COUNCIL ASSESSMENT REPORT

SYDNEY NORTH PLANNING PANEL

PANEL REFERENCE & DA NUMBER	PPSSNH- 613 – DA2025/0077
PROPOSAL	Demolition works and construction of shop top housing including strata subdivision
ADDRESS	<p>Lot 1 DP 900061, 28 Lawrence Street FRESHWATER NSW 2096</p> <p>Lot 1 DP 100563, 22 Lawrence Street FRESHWATER NSW 2096</p> <p>Lot 1 DP 578401, 20 Lawrence Street FRESHWATER NSW 2096</p> <p>Lot 45 DP 974653, 16 Lawrence Street FRESHWATER NSW 2096</p> <p>Lot 1 DP 595422, 10 Lawrence Street FRESHWATER NSW 2096</p>
APPLICANT	Md Living Construction Pty Ltd
OWNER	Lawrence Street Pty Ltd
DA LODGEMENT DATE	28 January 2025
APPLICATION TYPE	Development Application
REGIONALLY SIGNIFICANT CRITERIA	Section 2.19(1) and Clause 2 of Schedule 6 of State Environmental Planning Policy (Planning Systems) 2021 declare the proposal regionally significant, being development that has an estimated development cost of more than \$30 million (\$33,046,200).
CIV	\$34,523,329

Figure 1 - Building height blanket.

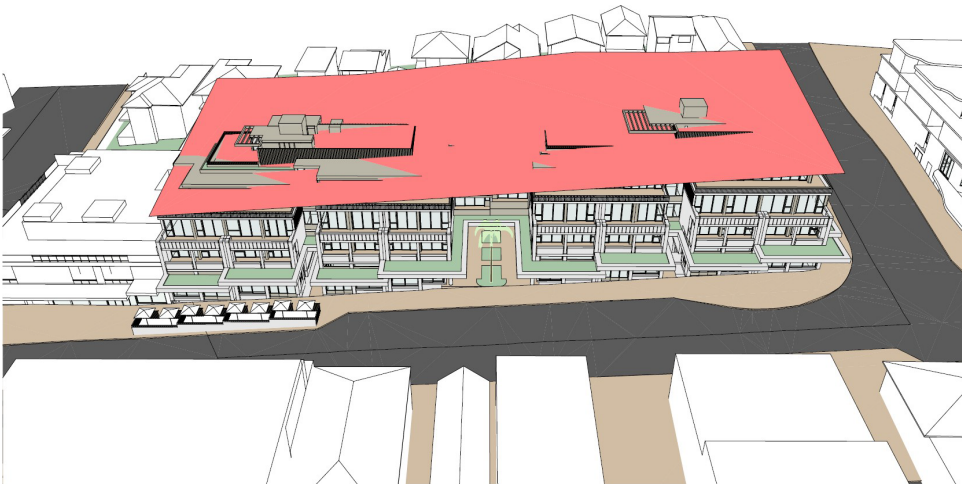
Development standard:	Height of buildings
Requirement:	WLEP -11m Affordable Housing Bonus – 13.45m
Proposed:	16.35m

Percentage variation to requirement:	48.6% to the WLEP development standard
	21.56% to the affordable housing bonus

Council is not satisfied that the Applicant has demonstrated that there are sufficient environmental planning grounds to justify the contravention of Clause 4.3 (Height of Buildings) for the following reasons:

Based on the proposal's inconsistency with objectives of the height of buildings development standard, and the lack of sufficient environmental planning grounds, it is considered that the proposed departure from the development standard is not acceptable and that flexibility in the application of the standard is inappropriate in this case.
